**Acton Board of Health
Agenda
December 15, 2008
Acton Memorial Library**

TO: Board of Health
FROM: Justin T. Snair
RE: Variance Request
26 Duggan Rd.

TO: Board of Health
FROM: Justin T. Snair
RE: Alternative Percolation Testing Approval
DATE: December 9, 2008

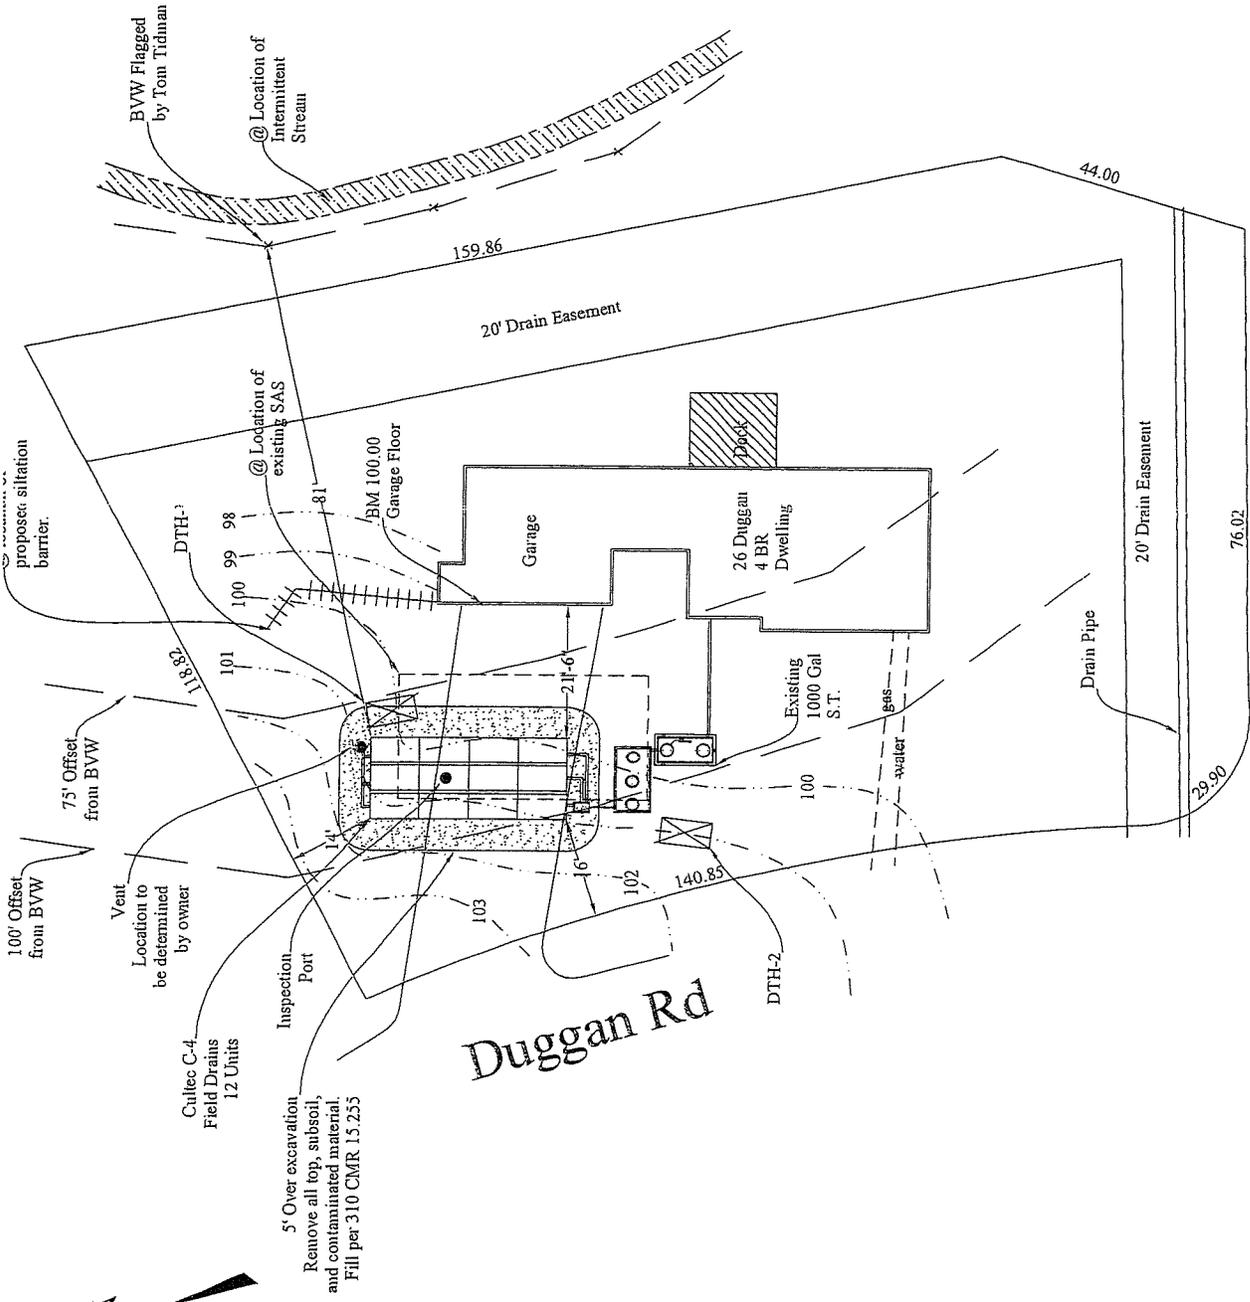
Variances Required

Local Variances Required

- A variance from Acton BoH regulation 16-6.2.7 is to be less than 100' from the BVW in an Aquifer Protection offset is proposed.
- A variance from Acton BoH regulation 11-8.1 is to be less than 800 sqft. A 643 sqft Culltec chamber is proposed.
